**CITY OF TEMPE
DEVELOPMENT REVIEW COMMISSION**

**Meeting Date: 02/13/2018
Agenda Item: 7**

ACTION: Request approval for a Use Permit to allow a restaurant in the General Industrial (GID) zoning district; Use Permit allow a drive-through; Use Permit to exceed 125% of the minimum required parking; and a Development Plan Review for a new 200 square foot building for THE FIX COFFEE, located at 1445 West Auto Drive. The applicant is Matthew Stewart.

BACKGROUND INFORMATION: THE FIX COFFEE (PL170228) is a new 200 square foot building with a drive-through. The request includes the following:

SHEET TITLE
LANDSCAPE PLAN
ISSUE DATE
Dec. 21, 2017
SHEET REVISION DATE
SHEET NUMBER
LP100

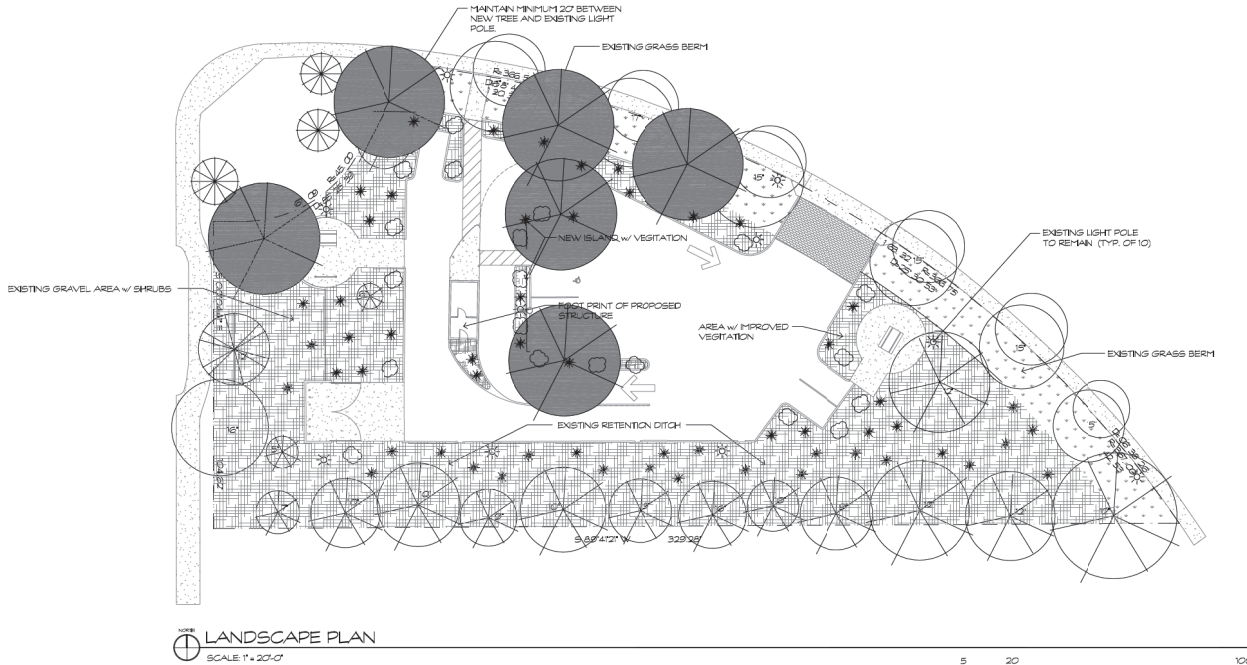
A landscape coverage of 57.3% is proposed. The majority of the landscaping is existing to remain but the applicant is adding trees and other specimens to meet the current code requirements. Staff has added two (2) conditions of approval under requiring that a minimum of 40% vegetative cover be provide in all landscape areas and the employee parking stall must have landscape islands on both side that meet the minimal requirements.

15. **Provide a minimum of 40% vegetative ground cover in landscape areas on-site and along the street frontages. Tree canopies shall not be counted towards this coverage requirement.**
